Re: Initial Submission Review: Green Valley Ranch East Master Plan Amendment No. 3
Application Number: DA-1662-40
Case Numbers: 2005-7006-03

Dear Mr. Jeremiah Fettig,
On behalf of Clayton Properties, Terracina Design is submitting an Initial Submission Review Green Valley Ranch East Master Plan Amendment No. 3 to address the comments dated April 24, 2025.

RE: Green Valley Ranch Master Plan Amendment 3

Amend 3:
Revised PA8,9,70
for increased
units, added
AAC, added and
revised park
space

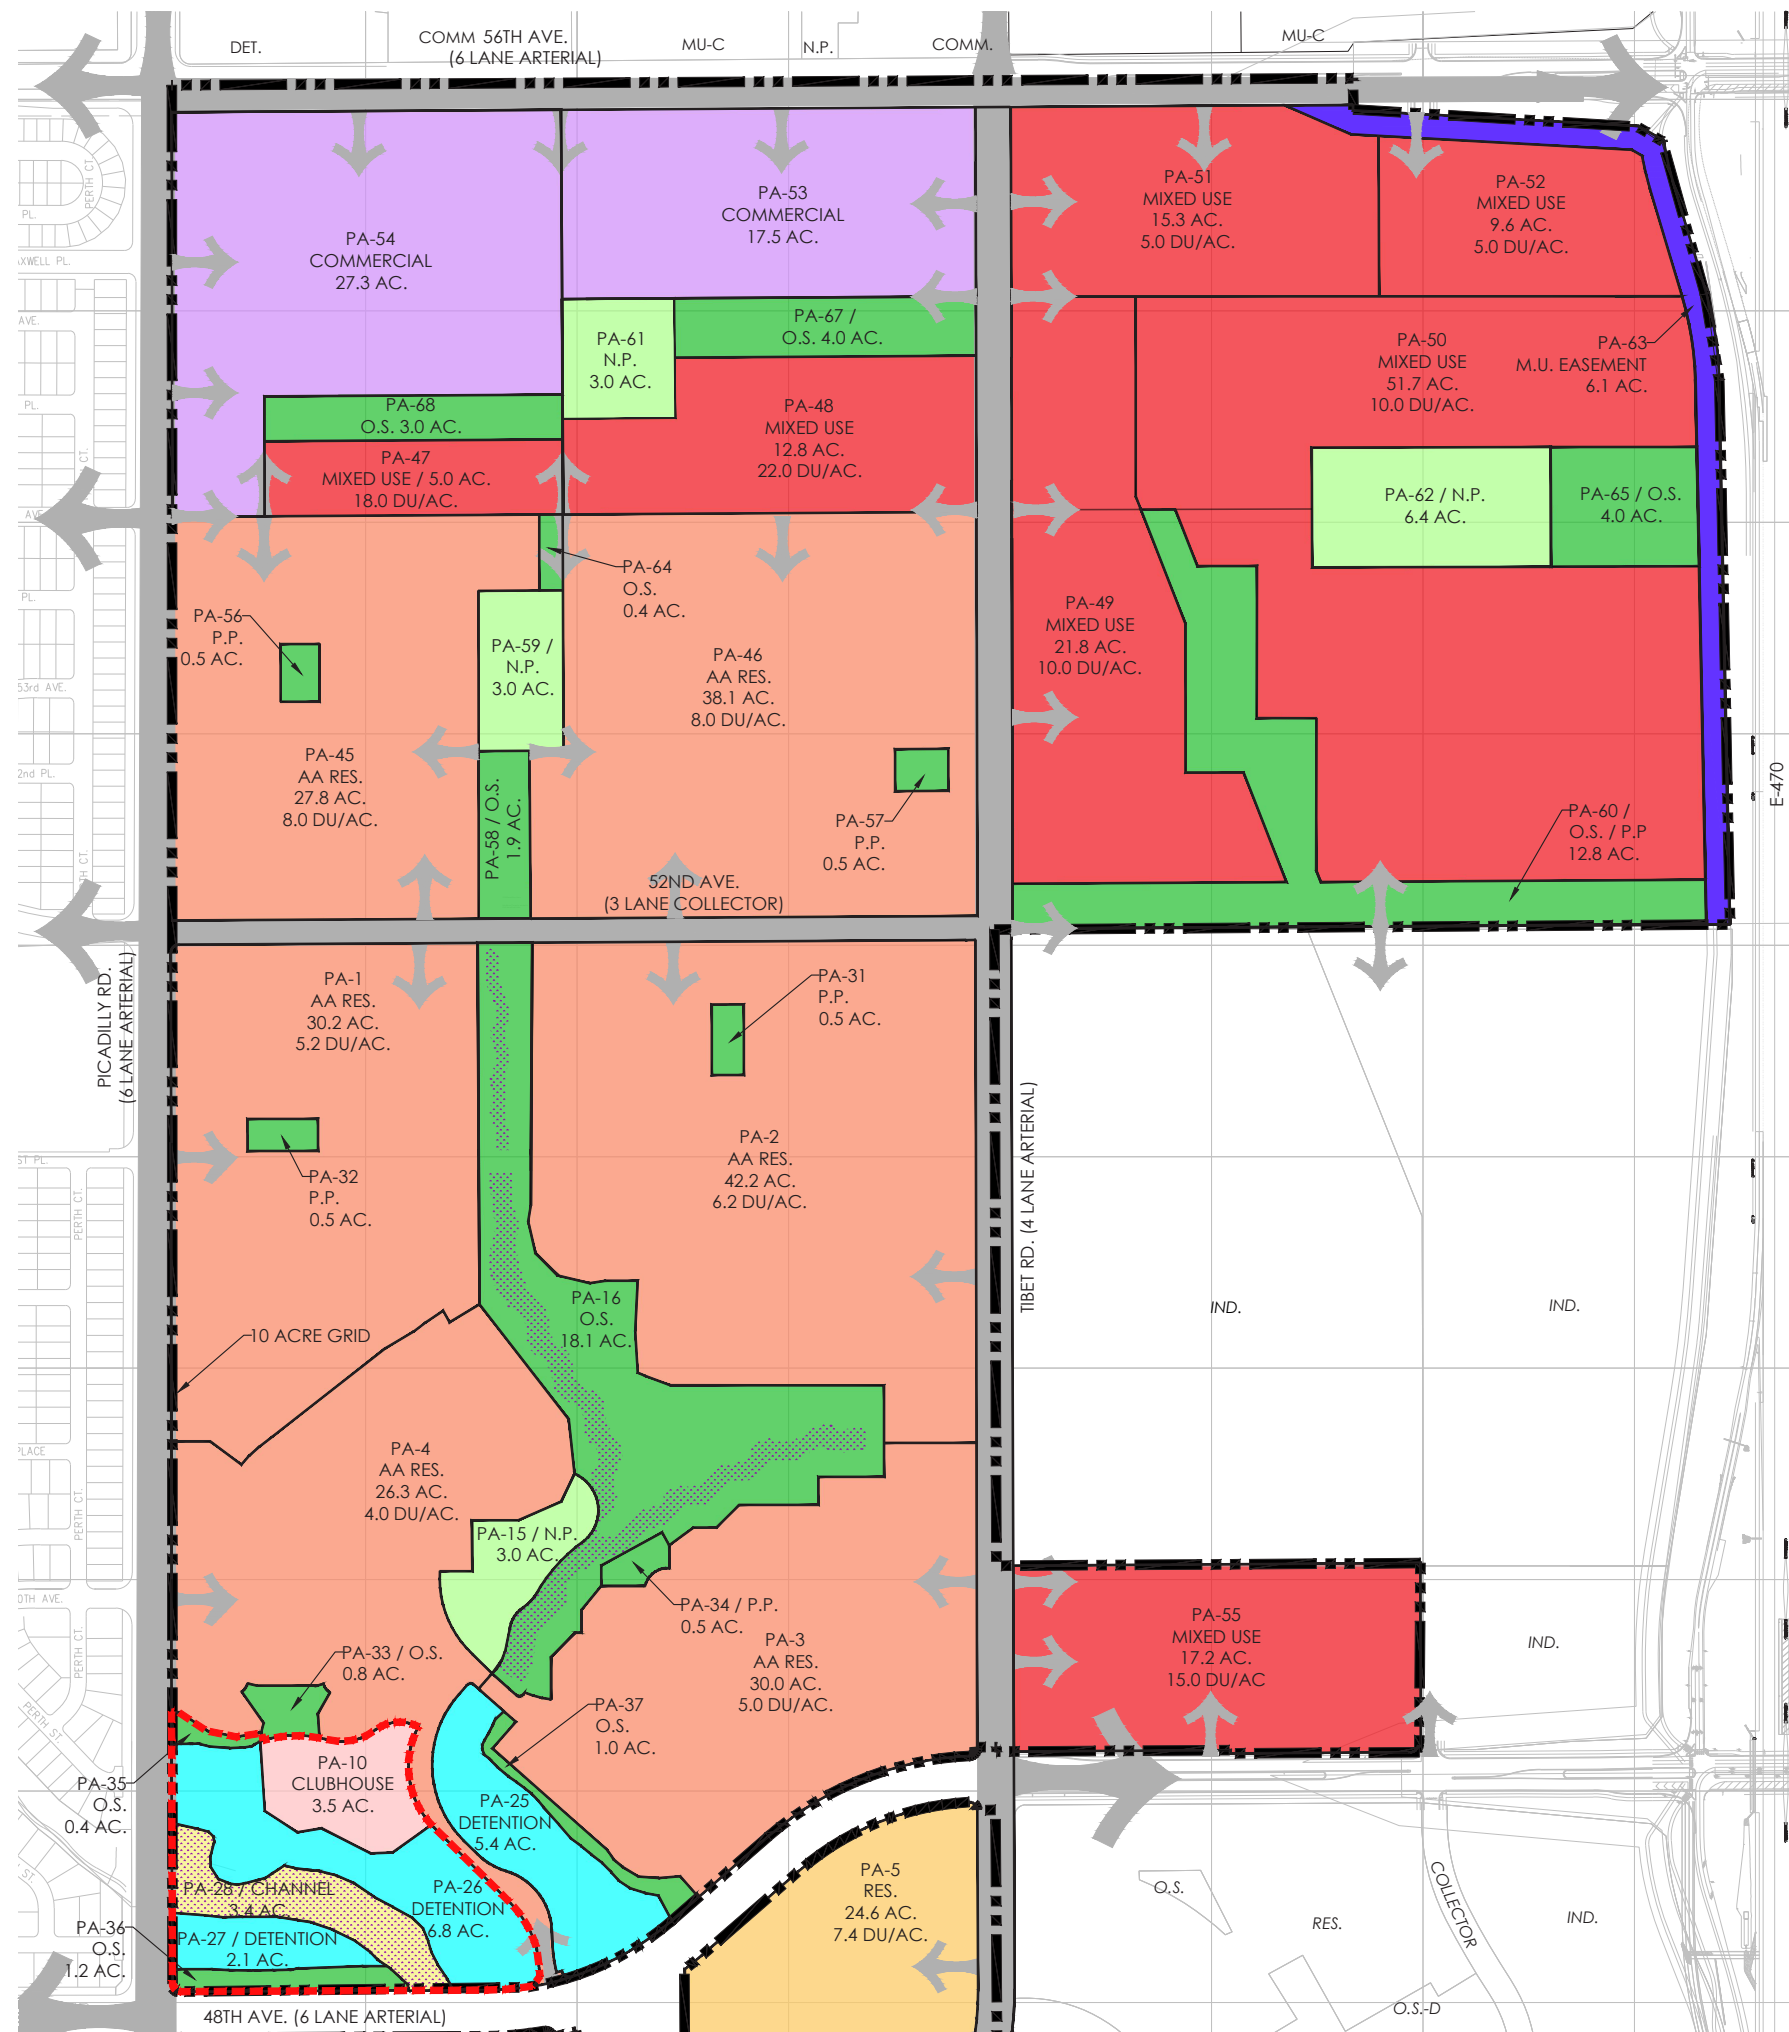
Show arrows for
rodway crossing over
Trib T.

TD RESPONSE:
ARROWS ADDED.

Sheet Title:
**LAND USE PLAN
SHEET 2**
Land Use Map, Matrix and
Standard Notes
Master Plan

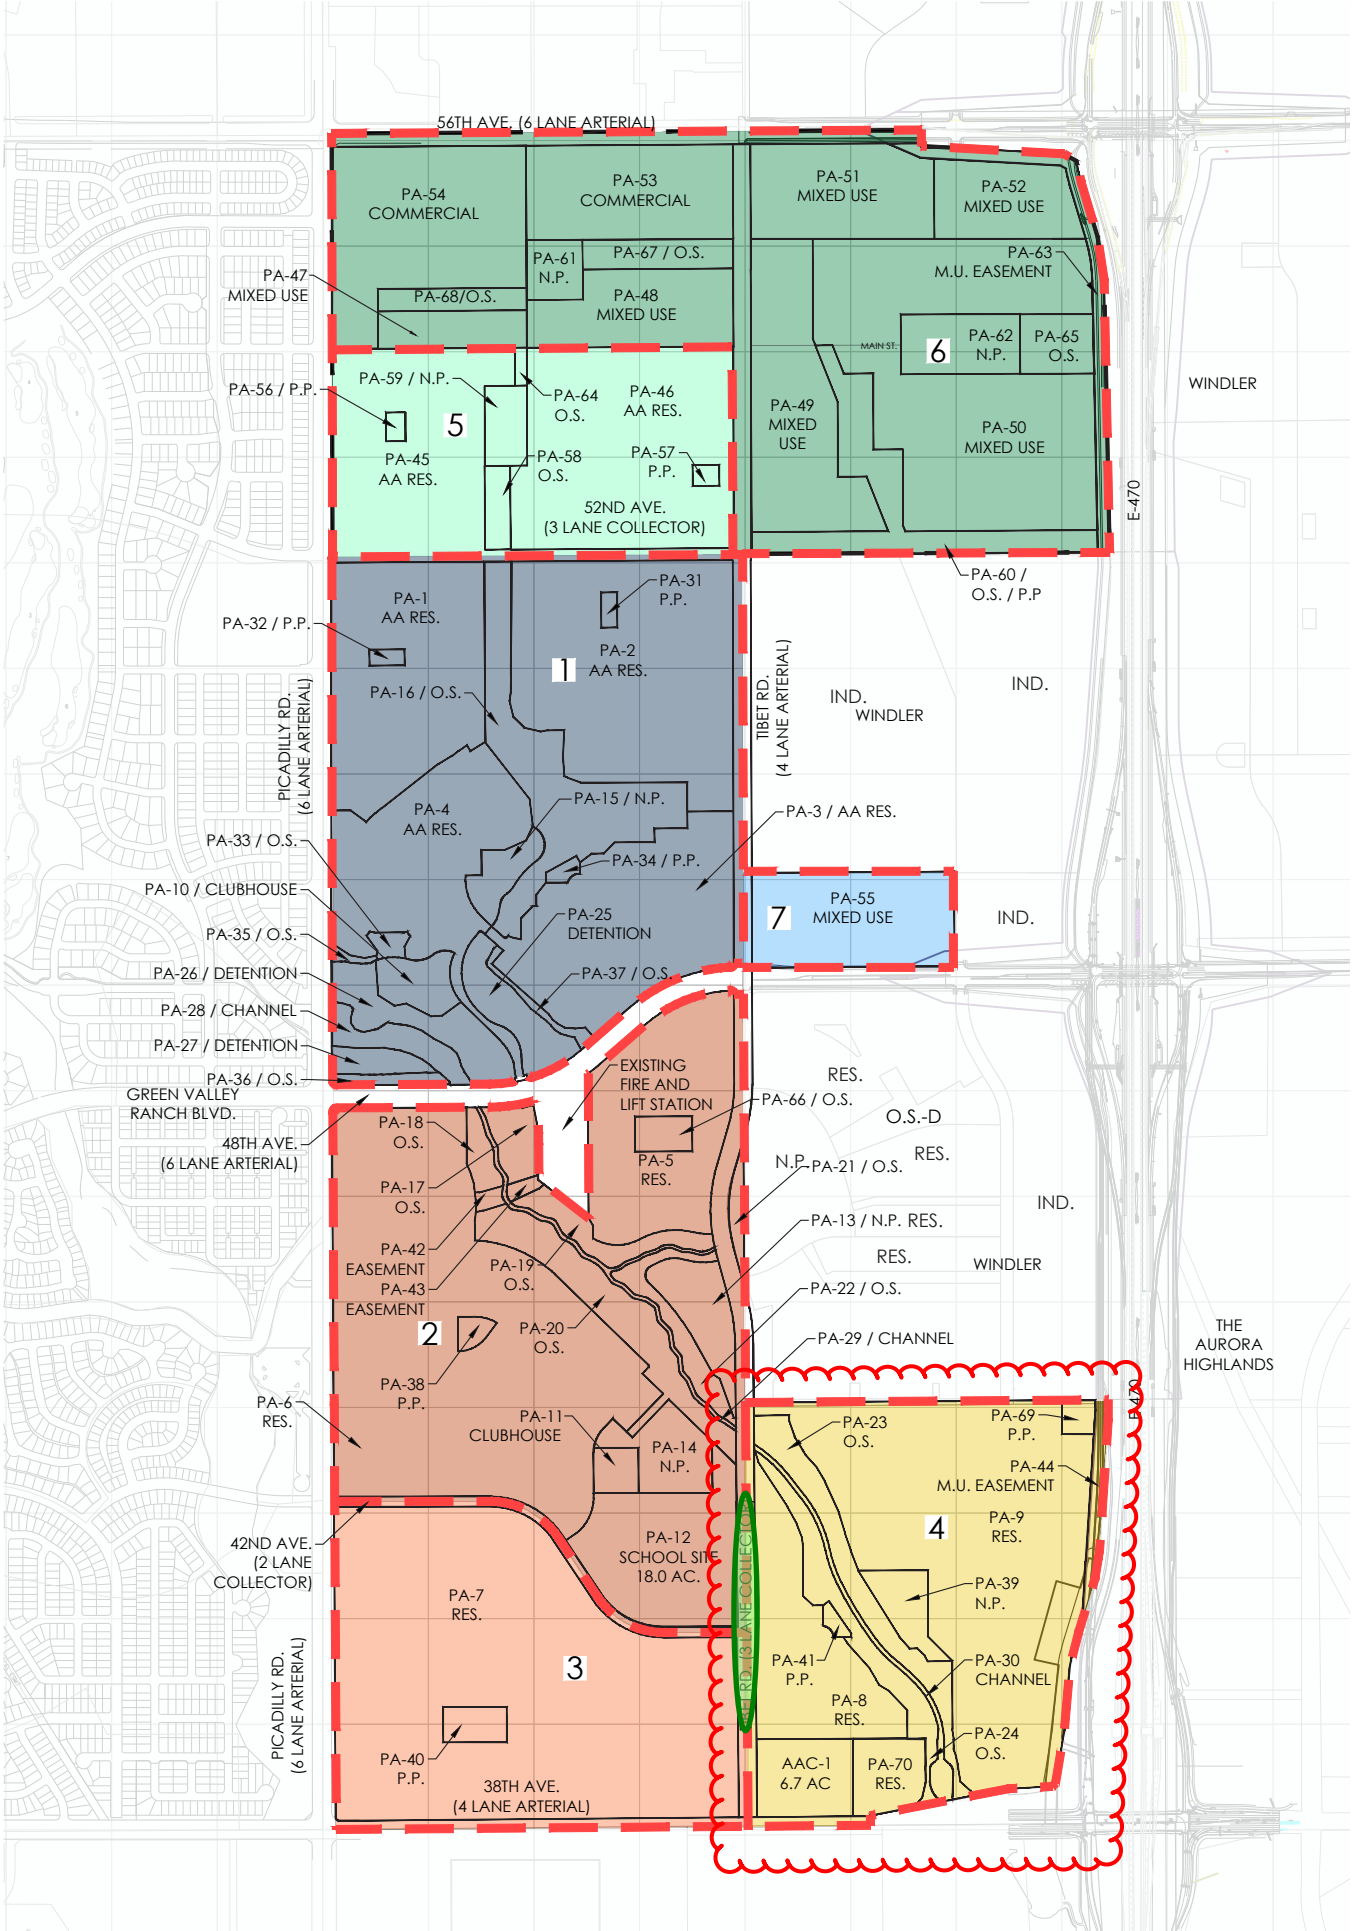
Show arrows for
roadway crossing
over Trib T.
